Docket: NRC-2021-0162
Safety Review of Light-Water Reactor Construction Permit Applications

Document: NRC-2021-0162-DRAFT-0002
Comment on FR Doc # 2021-27035

Comments on DNRL-ISG-2022-XX, Safety Review of Light-Water Power-Reactor Construction Permit Applications - Draft Interim Staff Guidance

Figure 1: Alternative I&C Regulatory Framework

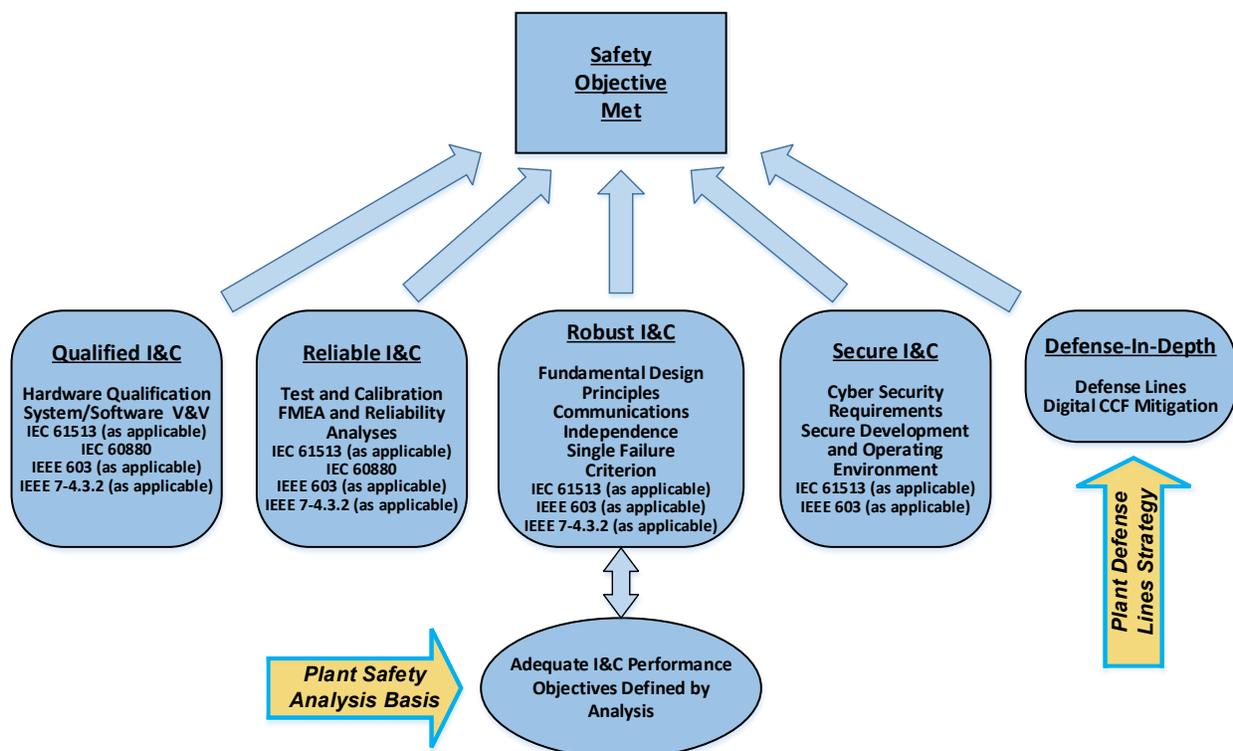
The fundamental regulatory challenge posed by modern I&C designs is not one related to technology or design, but the challenge is the effective communication and explanation of the integration such that it can be clearly and easily understood. An alternative I&C regulatory framework is proposed that organizes the key regulatory topics for I&C system reviews that is more accessible and understandable. The alternative I&C regulatory framework is illustrated in Figure 1.

The alternative I&C regulatory framework separates the D-in-D framework from the DRG placement as an element of robustness to provide a more prominent focus on a key part of the new plant design concepts. It also adds in a secure I&C element to reflect the overall importance to this topic to any digital I&C system design.

The alternative framework can be linked to IEEE Std 603⁶ and IEEE Std 7-4.3.2⁷ because of their historical use in the NRC review process. The alternative framework also can be linked to common international standards IEC 61513⁸ and IEC 60880⁹ because of their use in the broader international nuclear sector for I&C system technical requirements. This framework is consistent with both the DSRS and DRG for the common elements.
